HISTORIC AND DESIGN REVIEW COMMISSION

March 03, 2021

HDRC CASE NO: 2021-056
ADDRESS: 134 W MISTLETOE
LEGAL DESCRIPTION: NCB 1837 BLK 15 LOT 1 & W 14.28 FT OF 2
ZONING: R-4,H
CITY COUNCIL DIST.: 1
DISTRICT: Monte Vista Historic District
APPLICANT: Lyndsay Thorn
OWNER: John Archer/ARCHER JOHN CHRISTIAN
TYPE OF WORK: Construction of an ADA ramp, exterior modifications
APPLICATION RECEIVED: January 20, 2021
60-DAY REVIEW: Not applicable due to City Council Emergency Orders
CASE MANAGER: Stephanie Phillips
REQUEST:

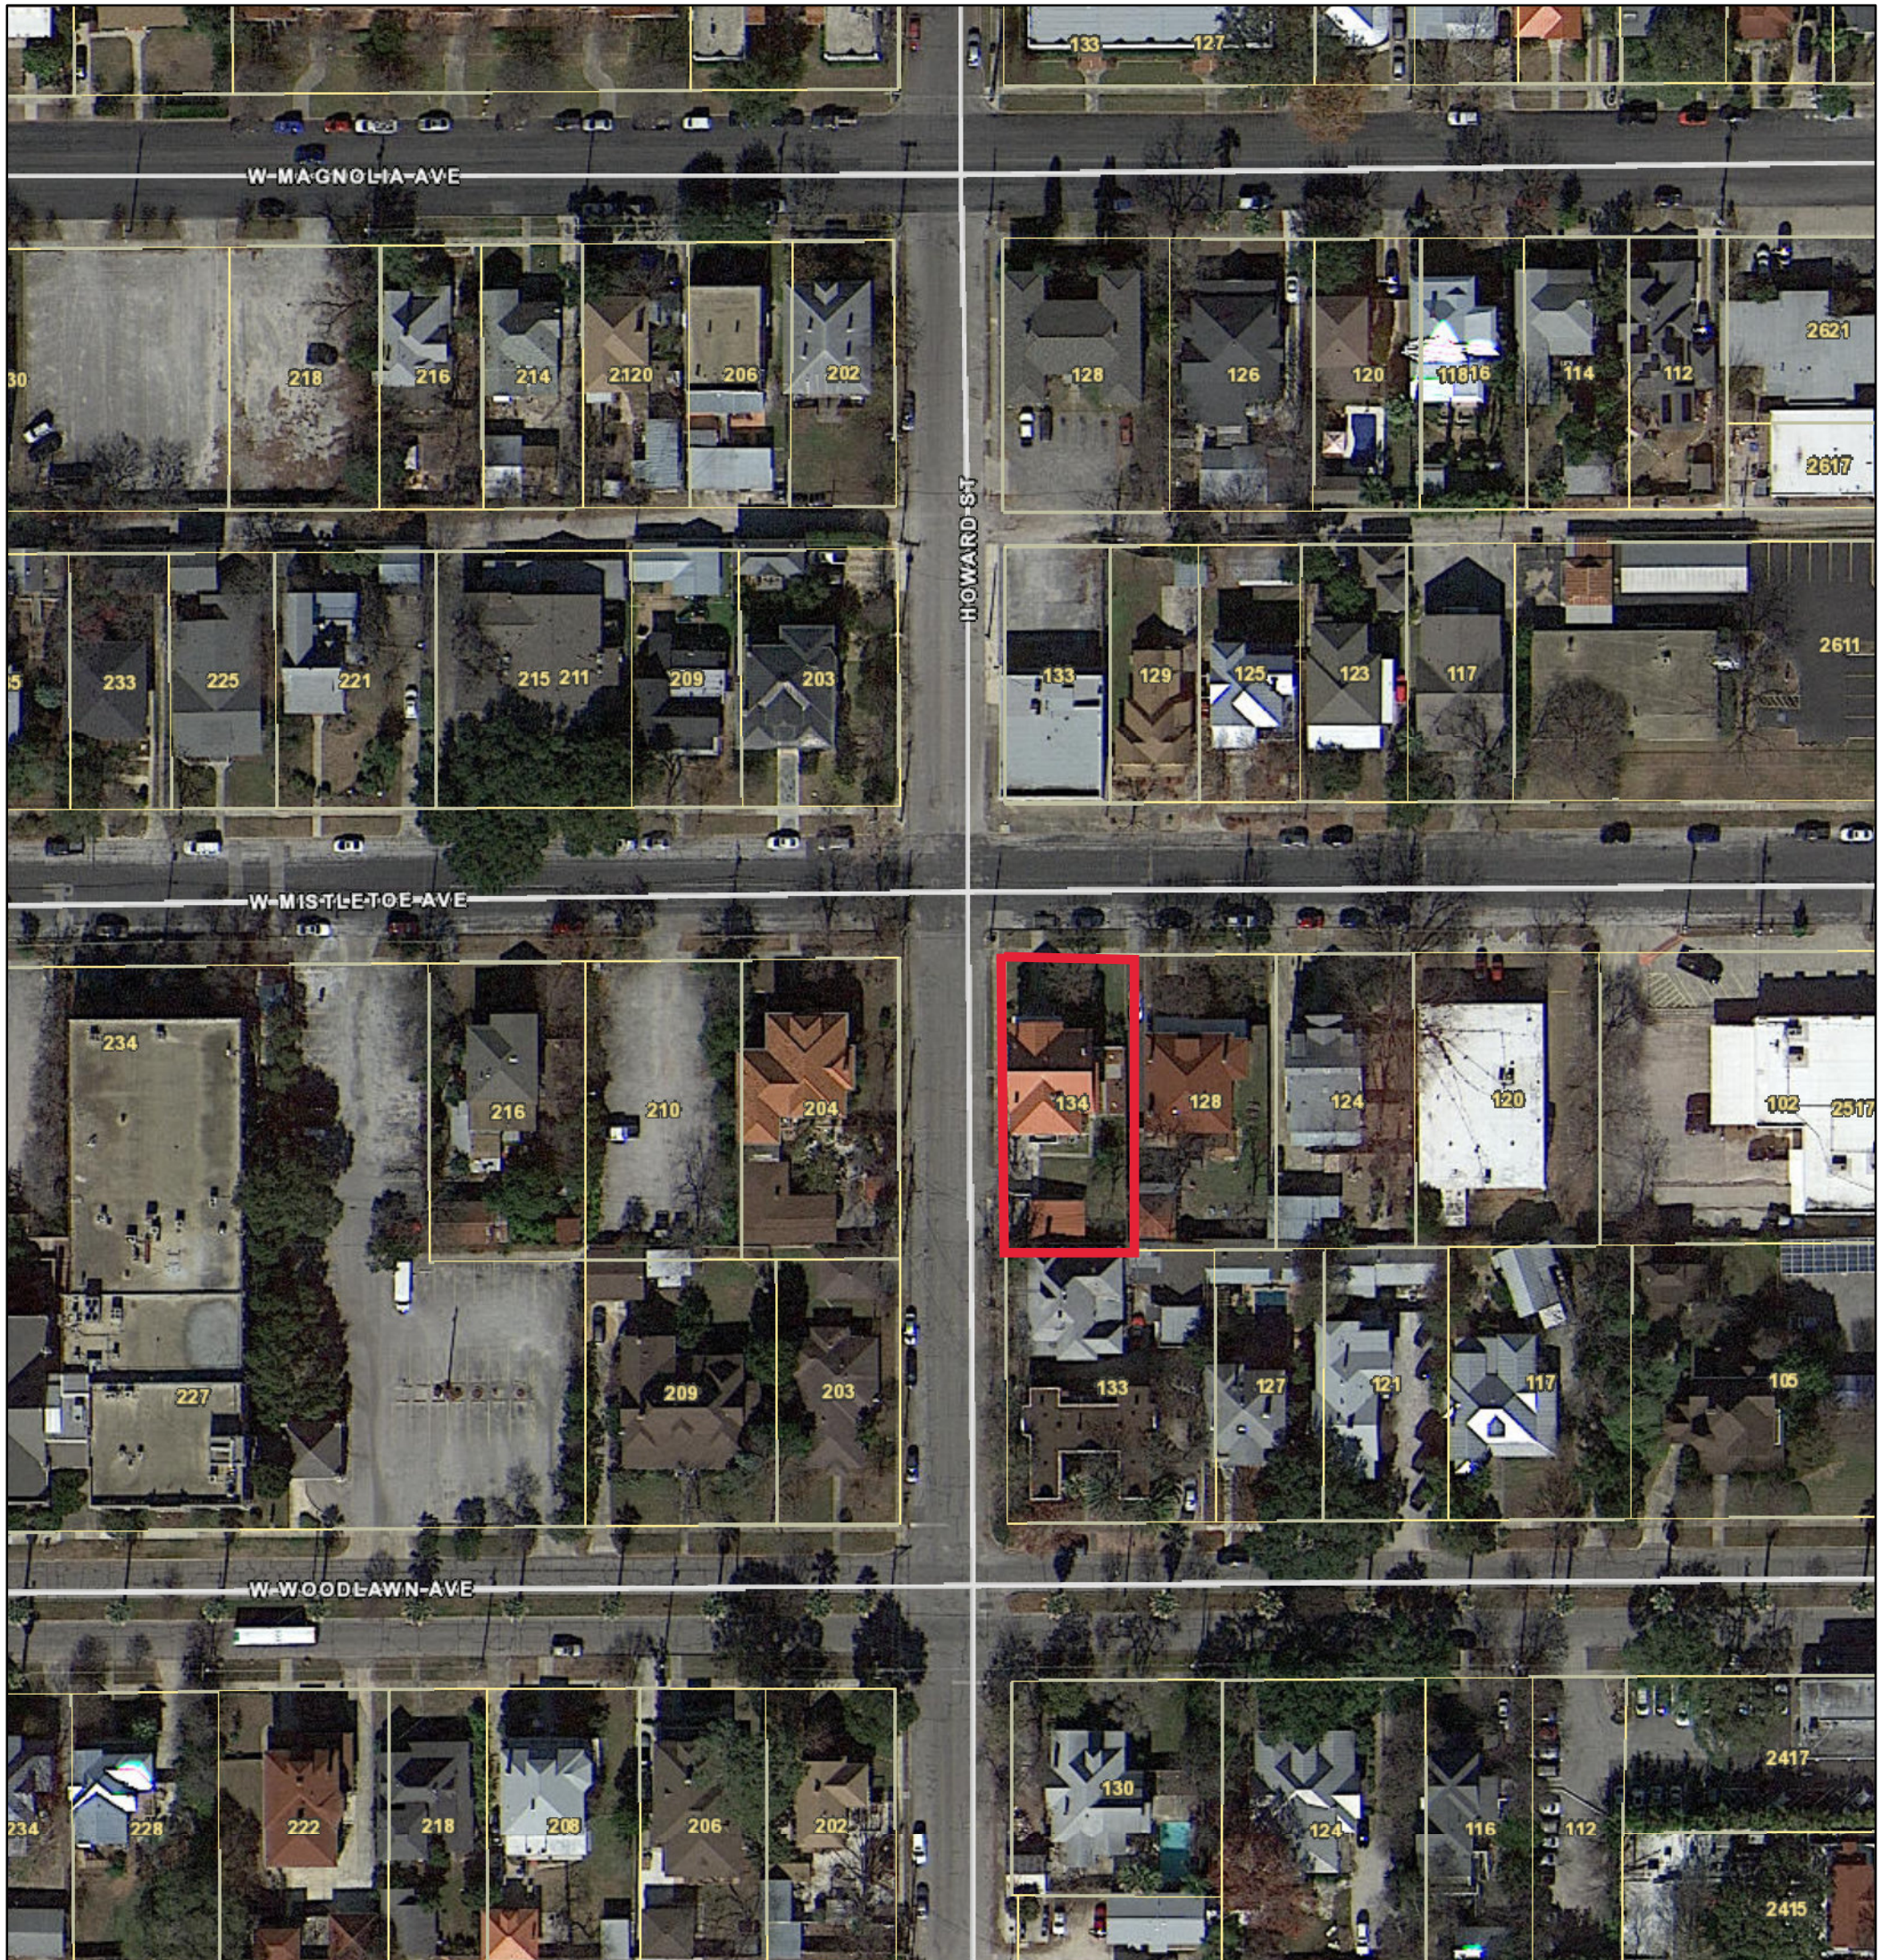
- b. **DOOR RELOCATION AND FENESTRATION MODIFICATIONS** – The applicant has proposed to relocate the existing side access door approximately 8’-8 ½” to the south to replace an existing window. A smaller window will also be removed that is currently adjacent to the existing door. The door is to be relocated to accommodate a new ADA ramp. While altering existing openings is generally discouraged, staff finds that the discreet location of this modification on a side façade, as well as its minimal impact to the overall historic character and fenestration pattern of the building, is appropriate.

- c. **ADA RAMP** – The applicant has proposed to construct a wooden ADA ramp on the west elevation of the home. According to the applicant, these modifications are to allow the owners more accessible entry to the house, while preserving the historic front entrance and providing an opportunity for an accessible restroom off the kitchen at the previous location of the existing door and stairs. A similar railing to the existing will be installed, and the same colors as existing will be maintained on all exterior modifications. According to the Historic Design Guidelines for Site Elements, the preferred location of new ramps is at the side or rear of the building when convenient for the user. Minimize the damage to the historic character and materials of the building and sidewalk while complying with all aspects of accessibility requirements. As noted in finding b, altering existing doors is generally discouraged, staff finds that the discreet location of this modification on a side façade, as well as its minimal impact to the overall historic character of the building, is consistent with the Guidelines.

Staff recommends approval of the request items based on findings a through c with the following stipulations:

- i. That the windows be salvaged and stored on site to be used for repairs or in future construction projects.
